Product Change Notification

Change Notification #: 112893 - 00
Change Title: Intel® Server System R1208GL4DS,
R1208GZ4GC, R1208GZ4GS9,
R1304GL4DS9, R1304GZ4GC and
R1304GZ4GS9
PCN 112893-00, Product Material
Change screw type
Date of Publication: February 21, 2014

Three Tap Screw Holes for Front End

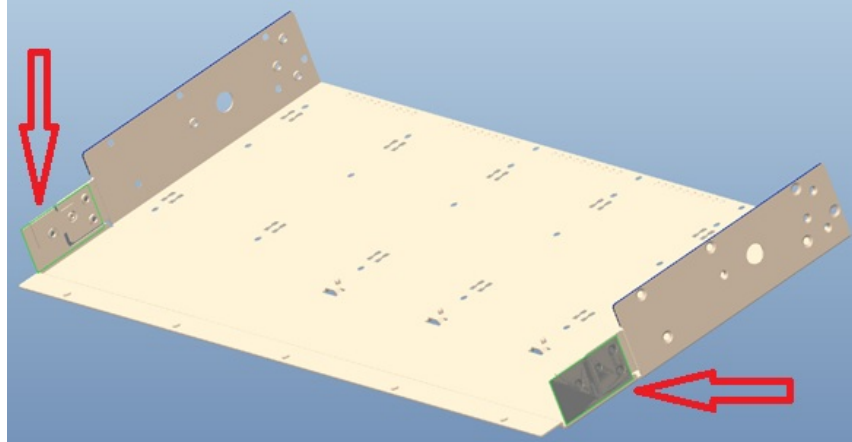
1. All #2 Phillips* screws used to secure the front drive bay module to the chassis have been changed to Torx* type screws. See below picture:

These changes have been made as a product enhancement to prevent the possibility of the front drive bay module from becoming loose.
